CMS RPC – YE-4/1

CMS RPC – YE-4/1 Brackets
Installation test

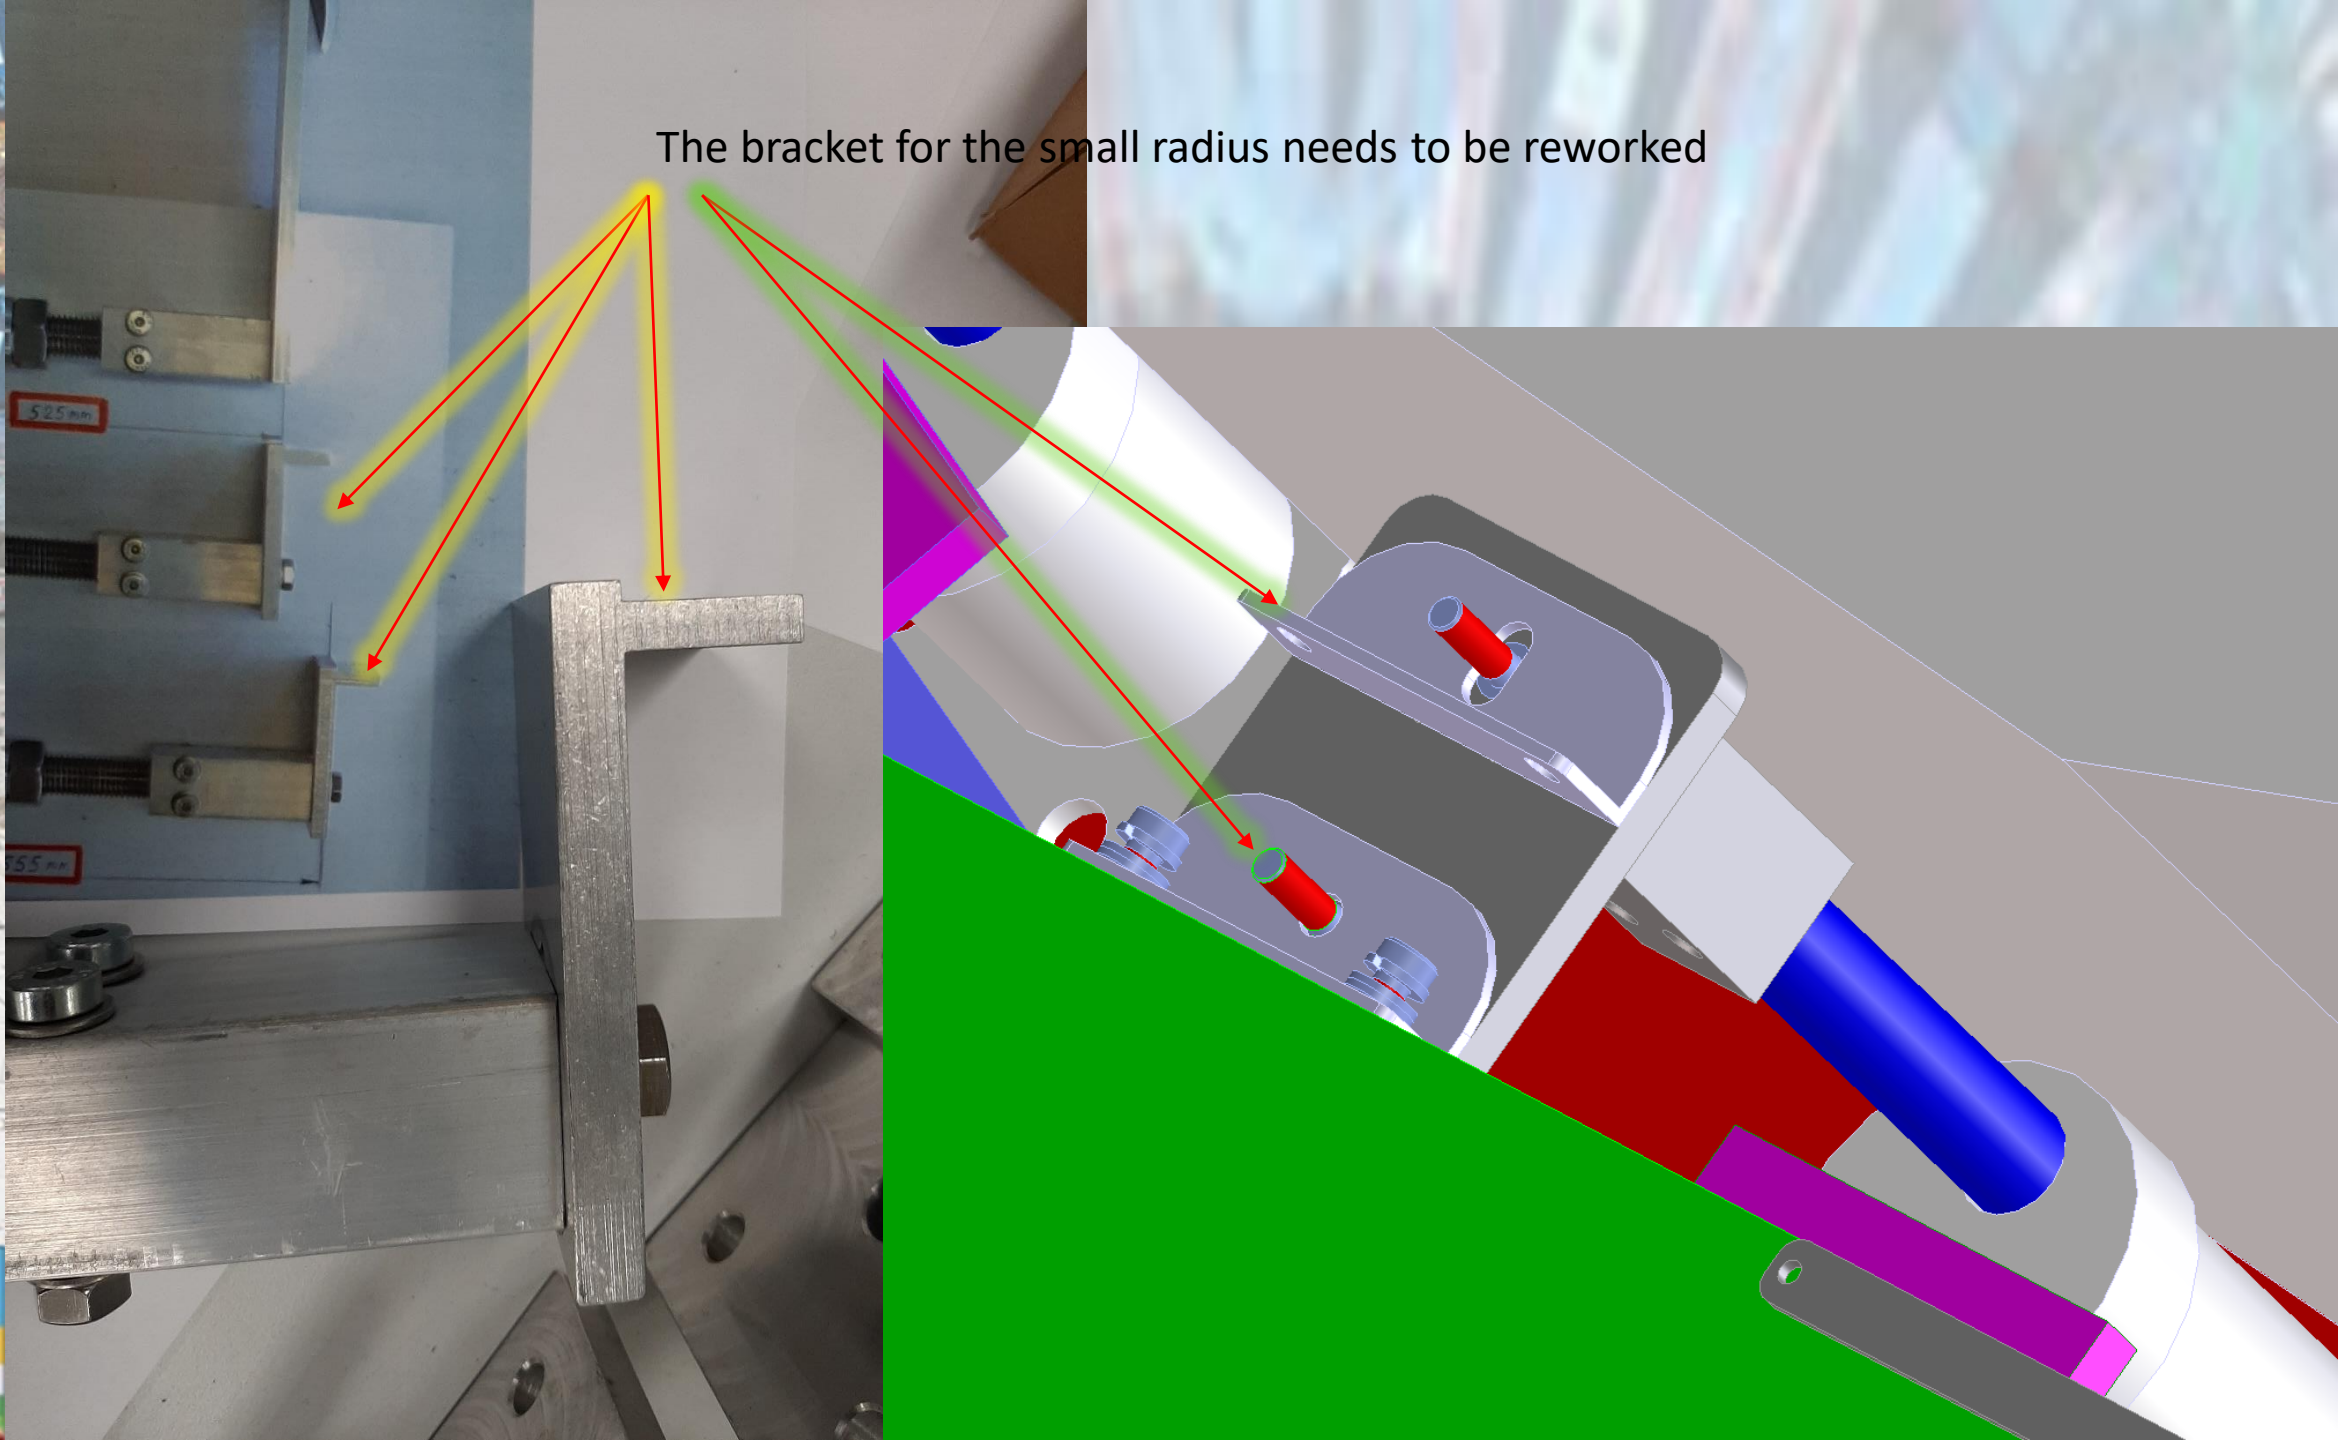
We need to constraint the rotation
for the bracket head.
And split or replace (thick washers)
the spacers

The third nut needs to come off from the top of the rod.
Some threads need to be fixed.

The bracket for the small radius needs to be reworked

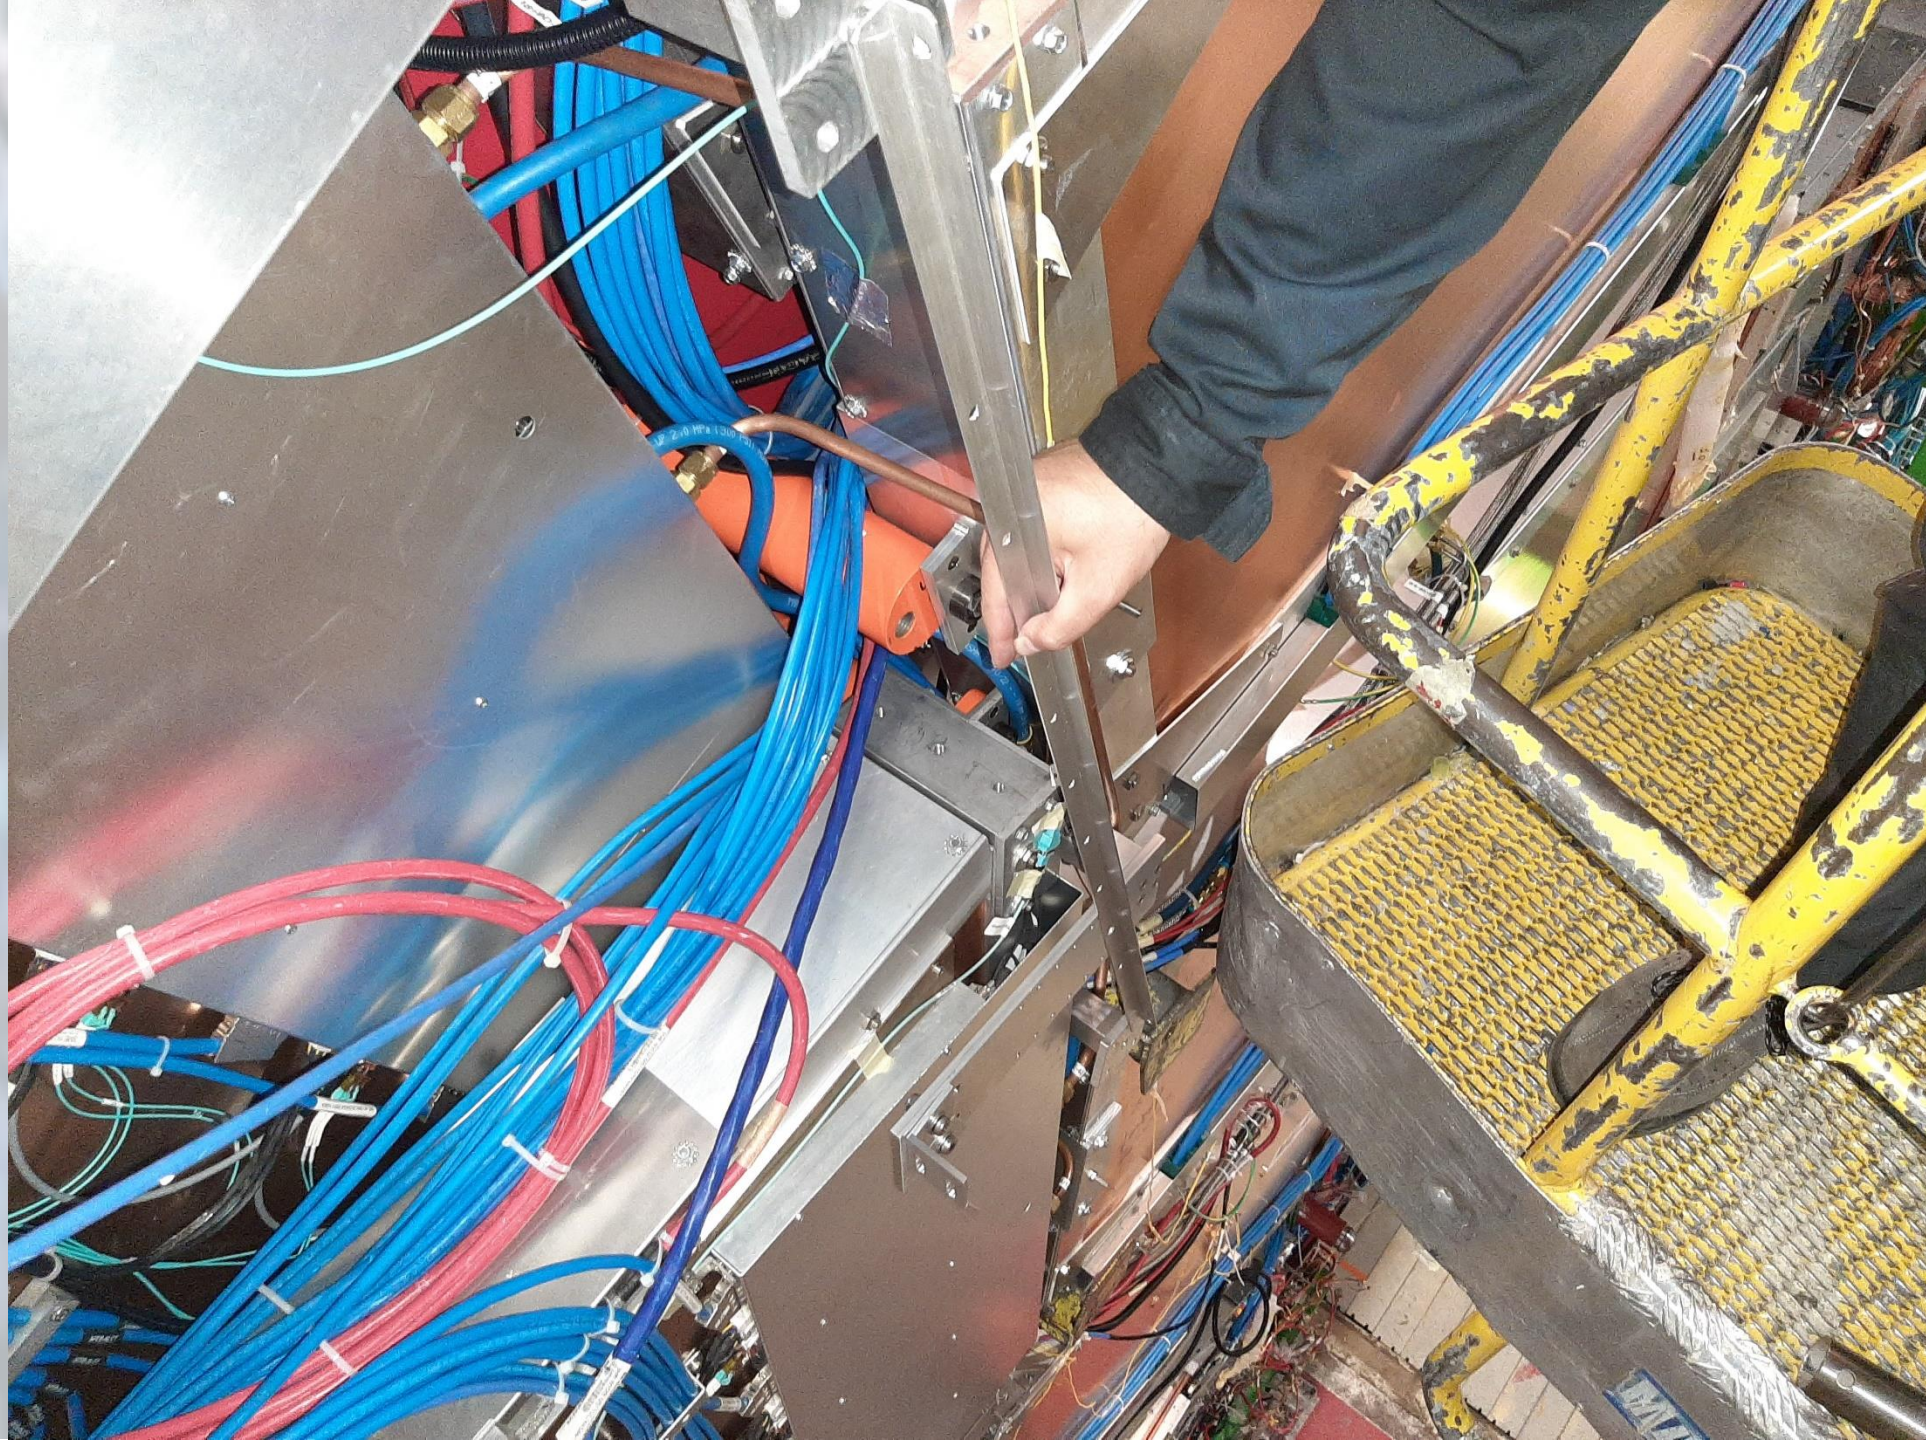
The bracket
needs to be at
list 1cm higher

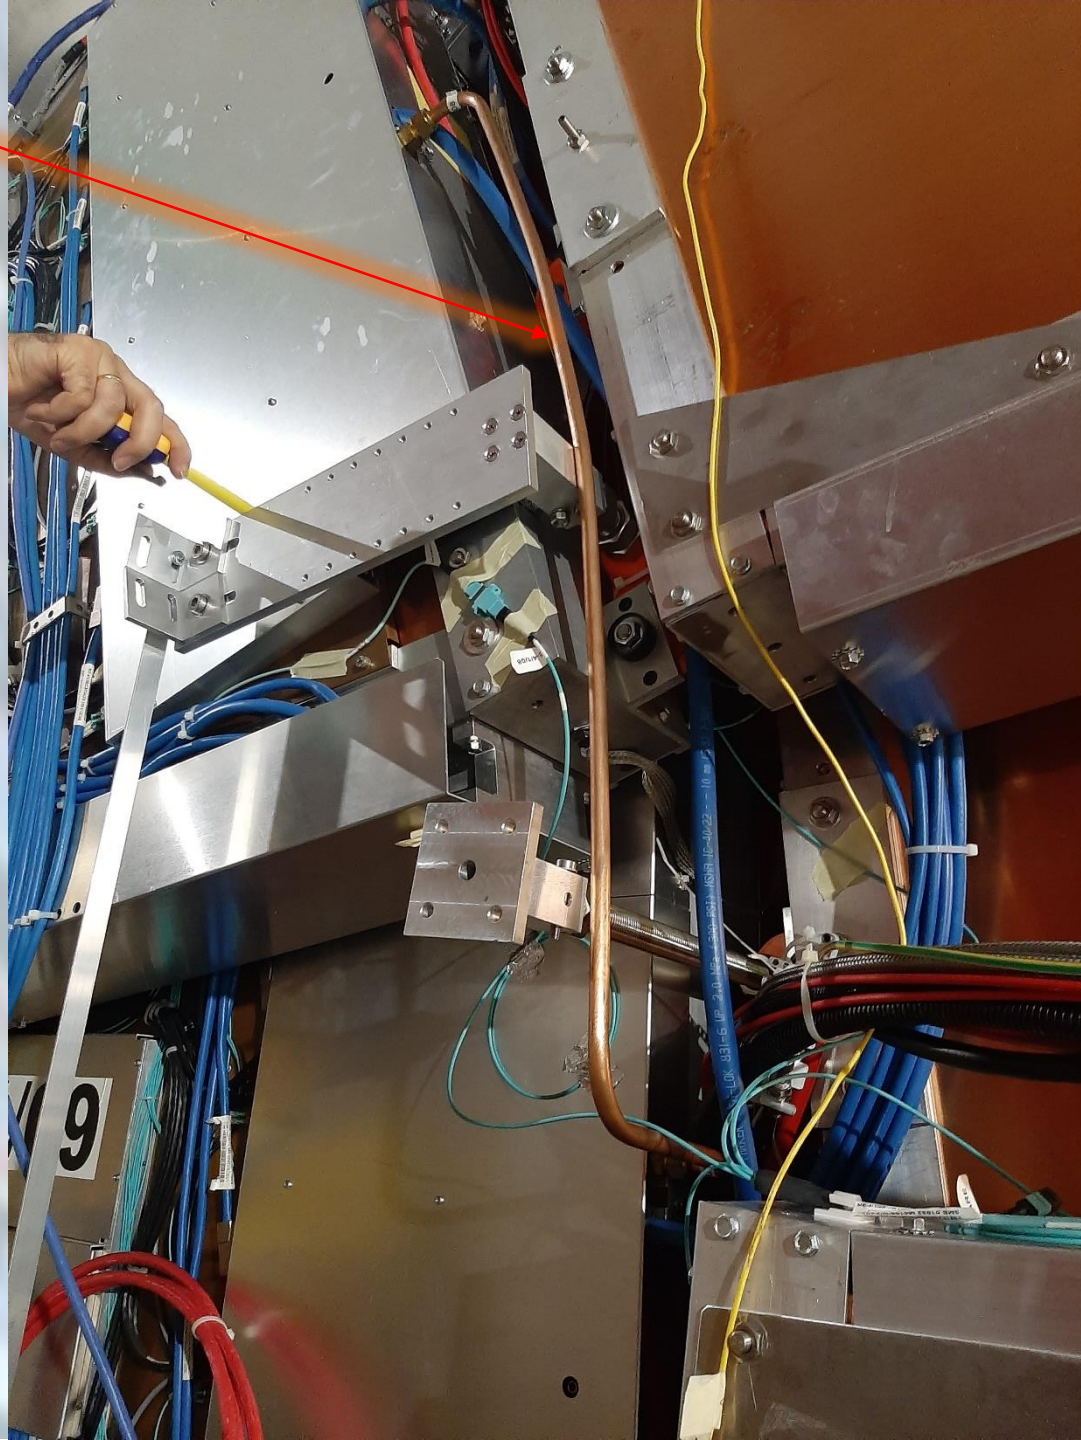
This copper pipe is obstructing the installation of the new brackets.

Re routing the pipe or at least gas leak test is needed after installation
